Wisconsin Department of Transportation

Proposal #41: 4996-25-71, WISC 2019 174

Sheboygan River Bridge

This is Addendum No. 02, which provides for the following:

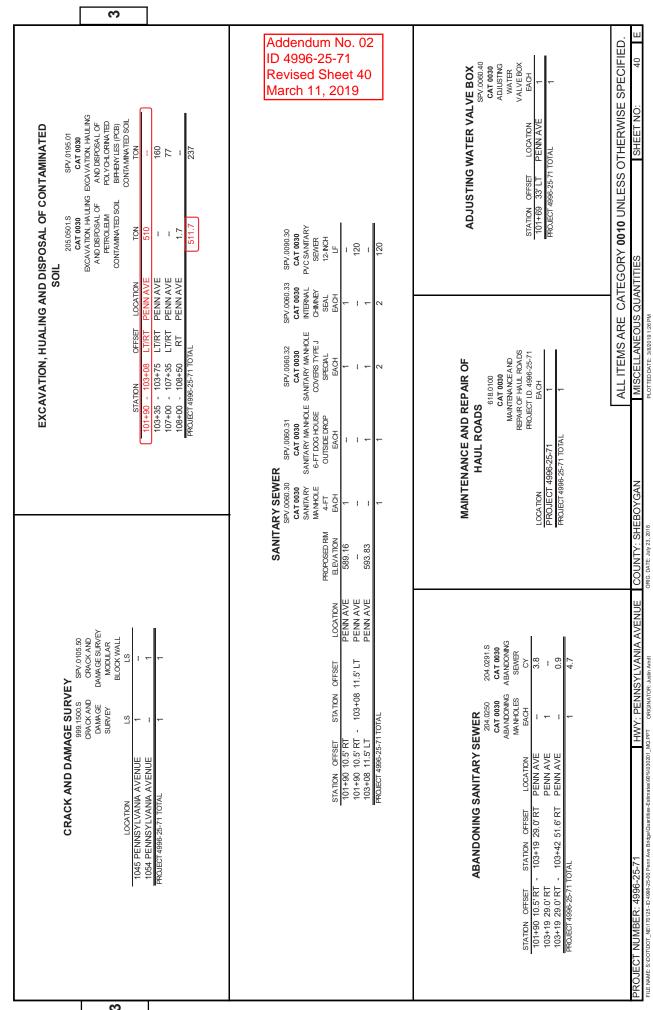
Add the following numbered paragraph after the first numbered paragraph under section titiled **A.2 Notice to the Contractor – Contaminated Soils Location(s)**:

2. Pennsylvania Avenue in the location of the new sanitary sewer installation from Station 101+90, 10.5' RT to 103+08, 11.5' LT from 2' to 5' bgs. Soil contains Chrysenes and must be managed. Approximately 300 cubic yards (approximately 510 tons at an estimated 1.7 tons per cubic yard) of soil will be excavated from this location.
